**ADDENDUM
NO. 01**

Edwardsburg Public Schools – Middle School and High School Mechanical Upgrades

ADDENDUM NO. 2

PROJECT: **Edwardsburg Middle School – Mechanical Upgrades**
69410 Section St.
Edwardsburg, MI 49112

SHEET TITLE FIRST FLOOR LIGHTING DEMOLITION
PLAN - UNIT C DATE JANUARY 16, 2026
SHEET NUMBER ED 201C
SCALE: NO SCALE
A2
21-201.041

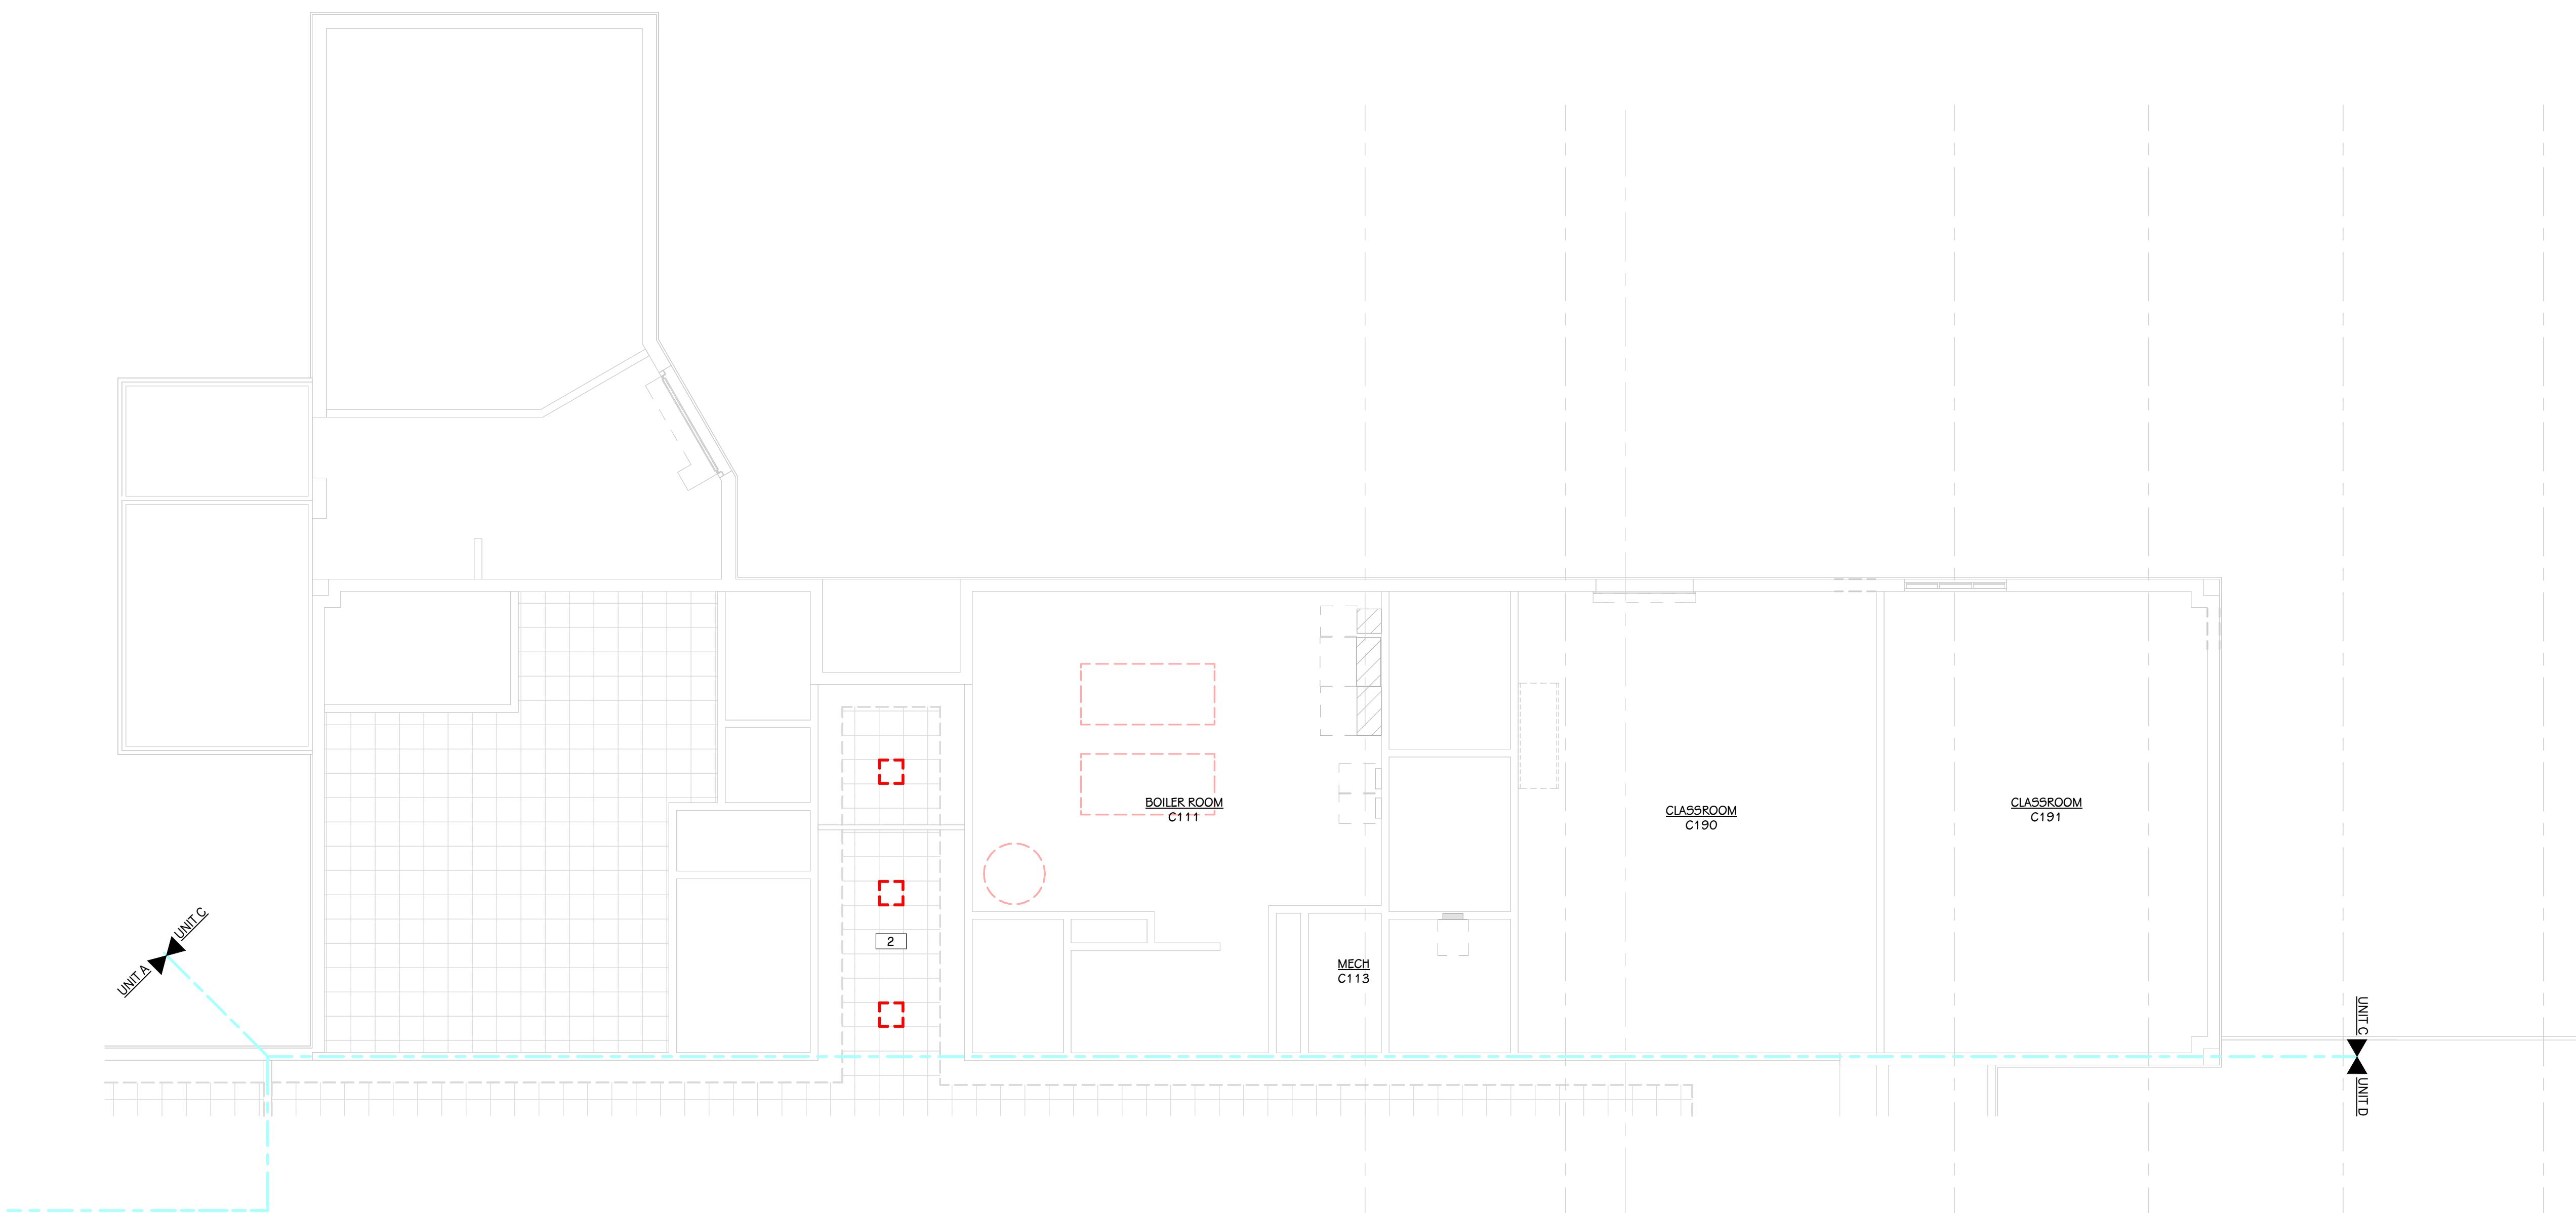
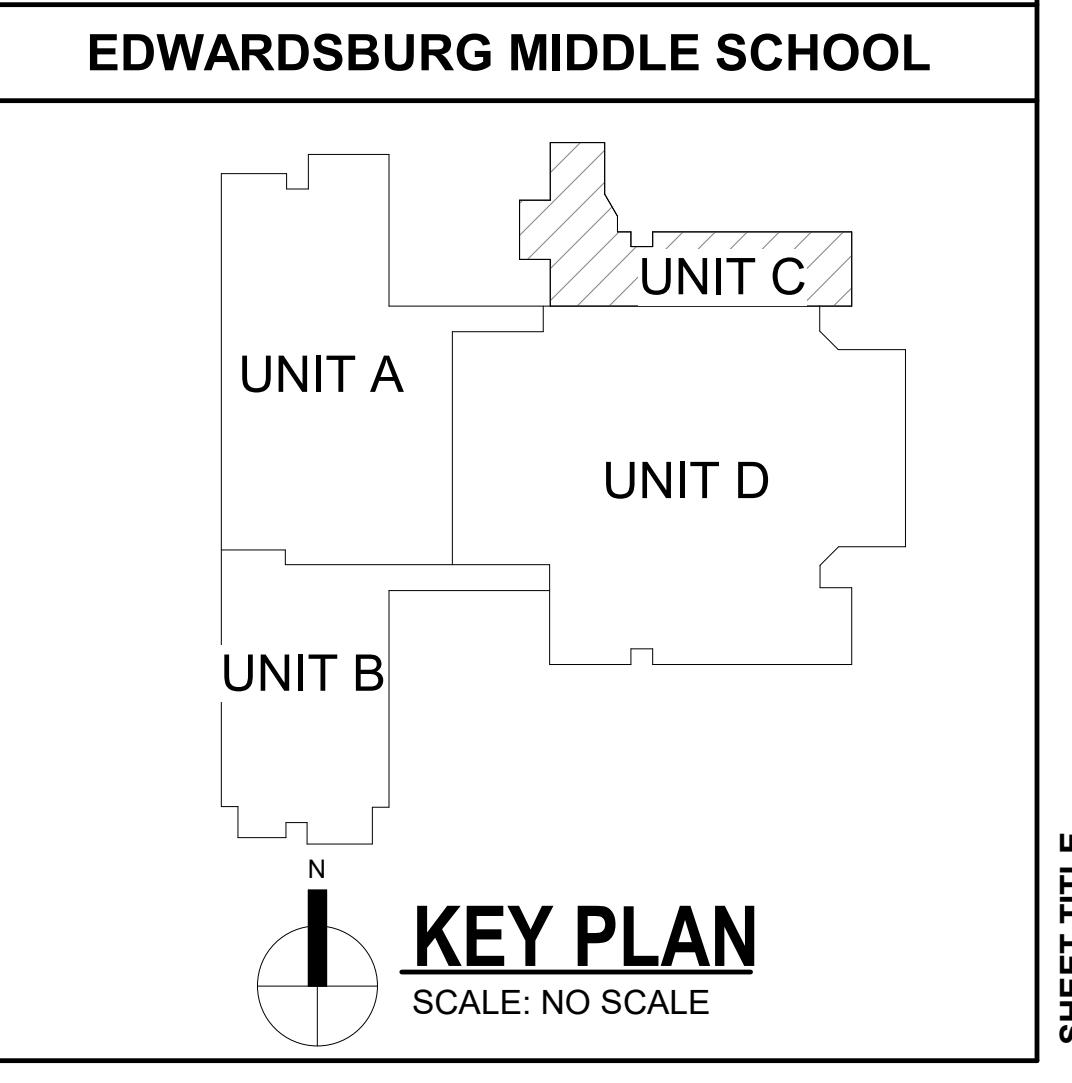
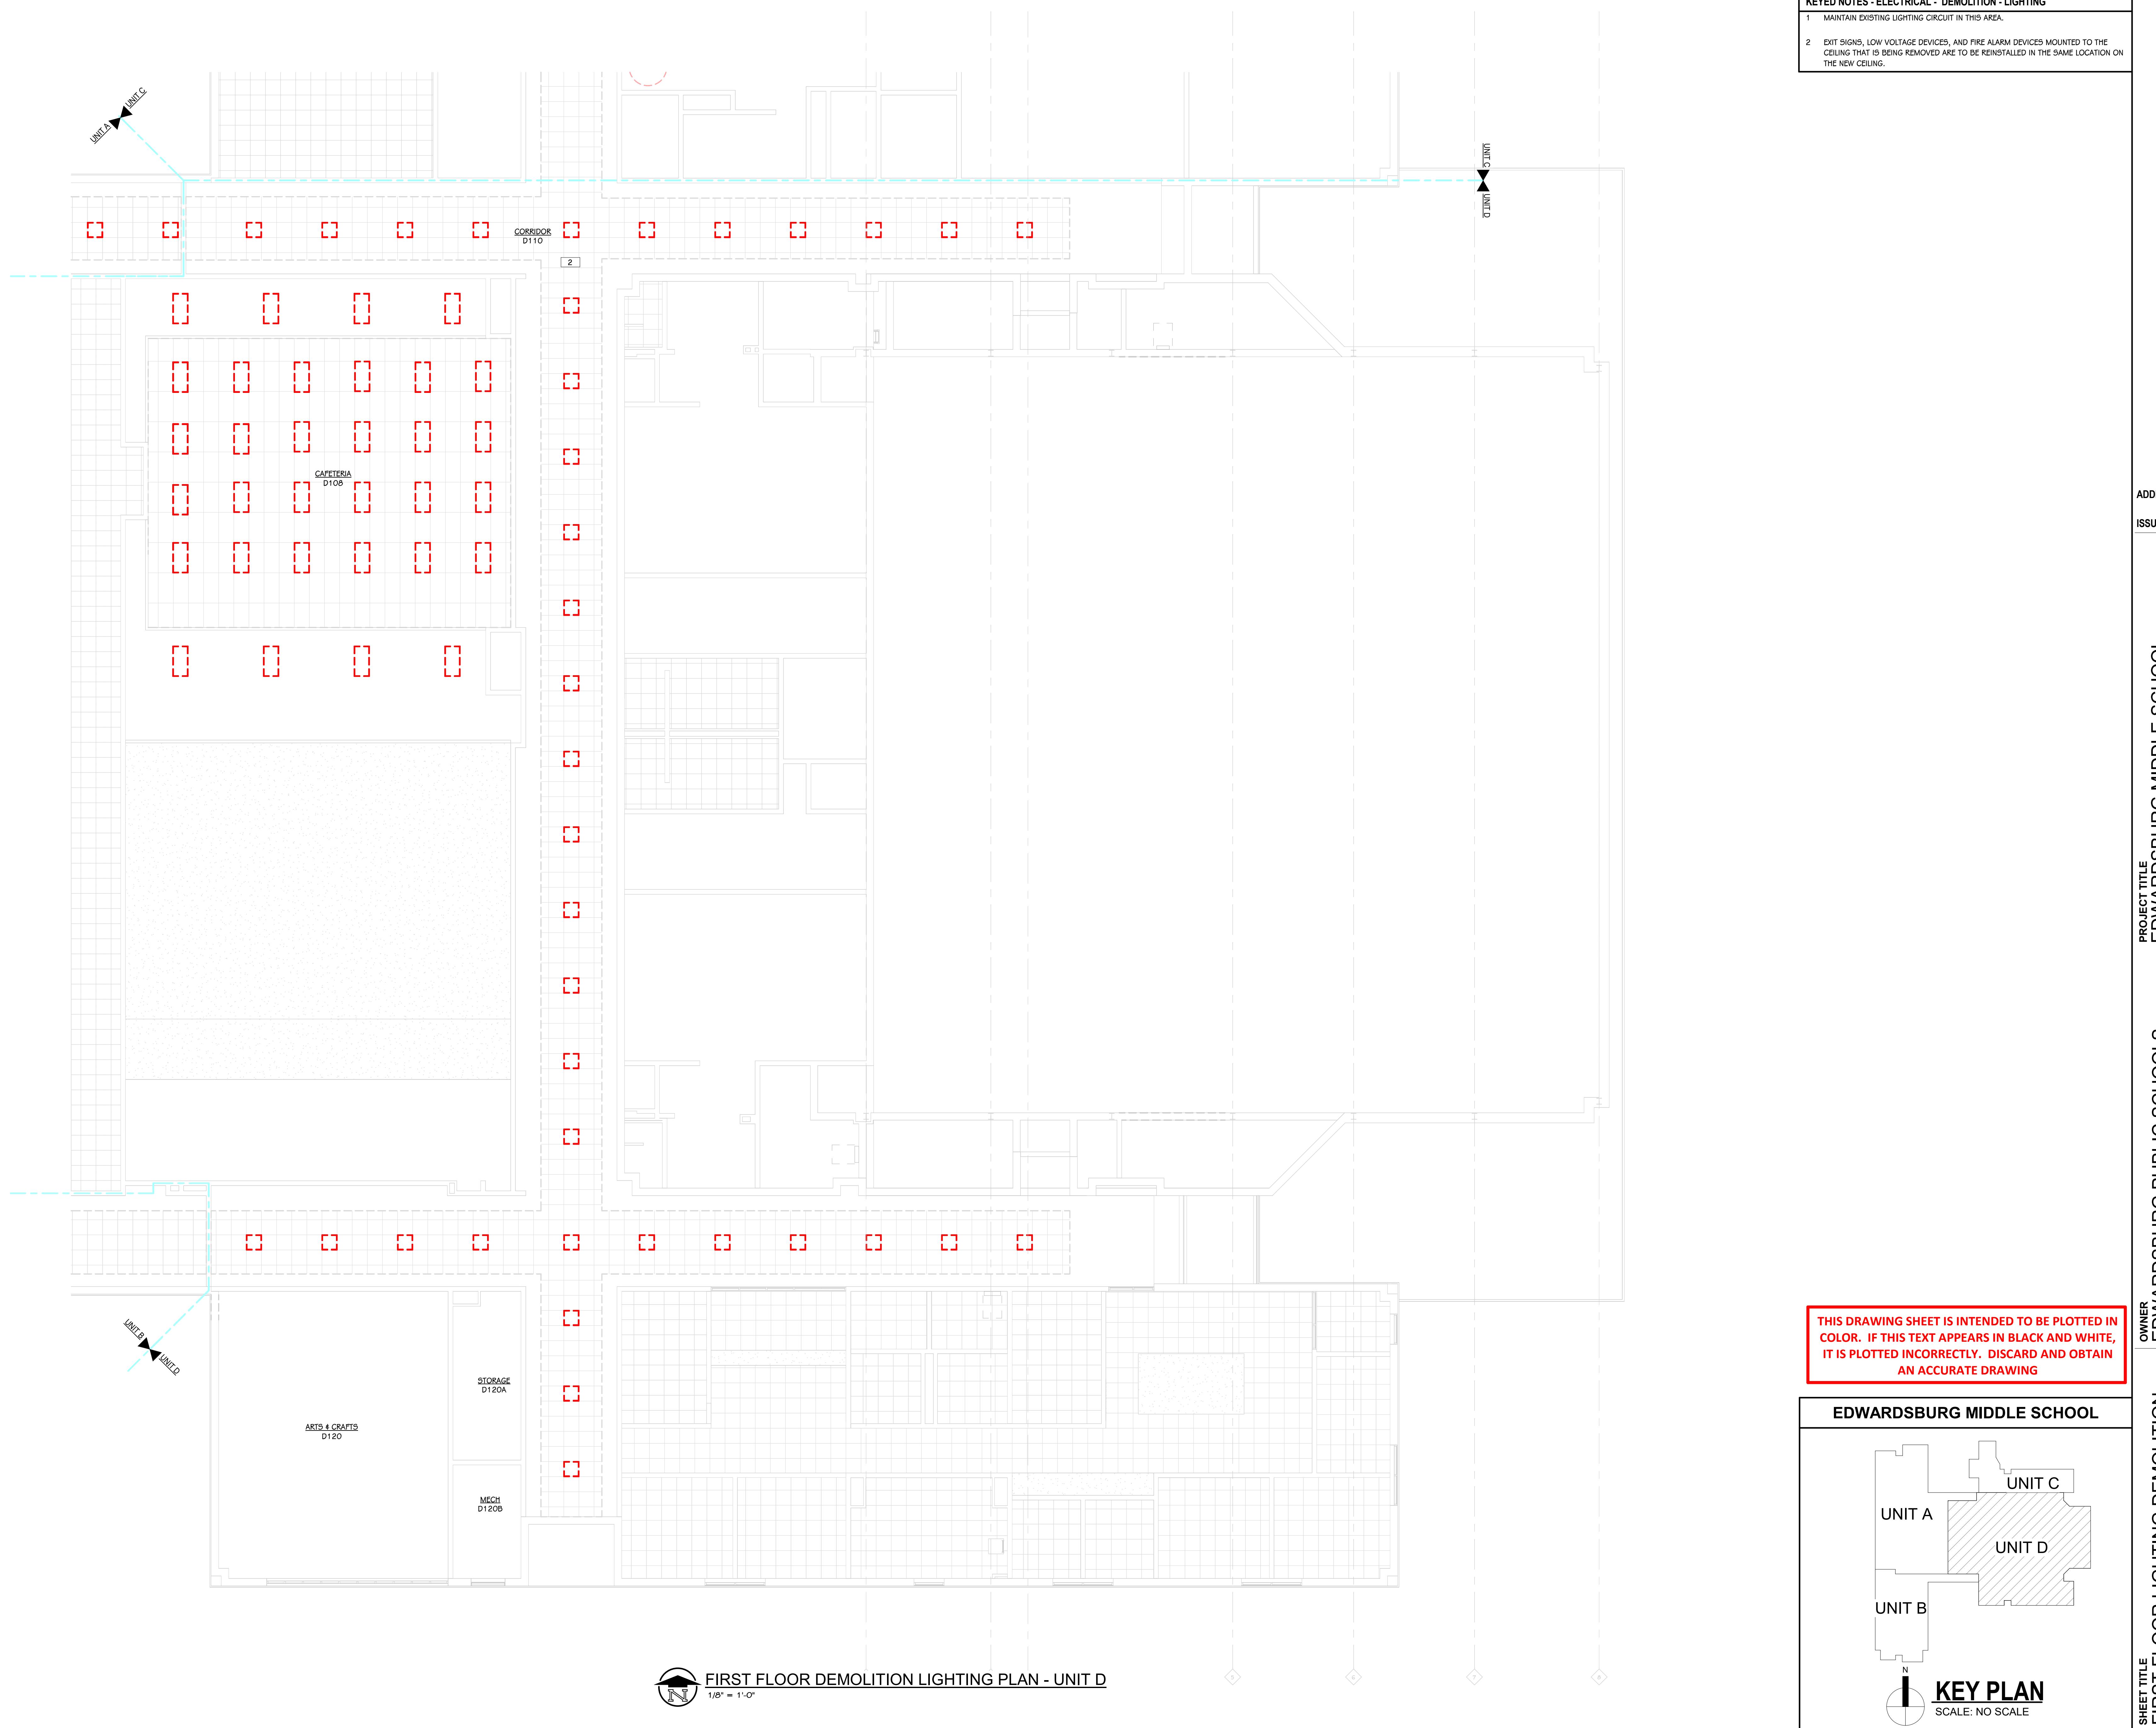
ED 201A, ED 201B, ED 201C, and ED 201D – Added lighting and lighting controls demolition drawings.
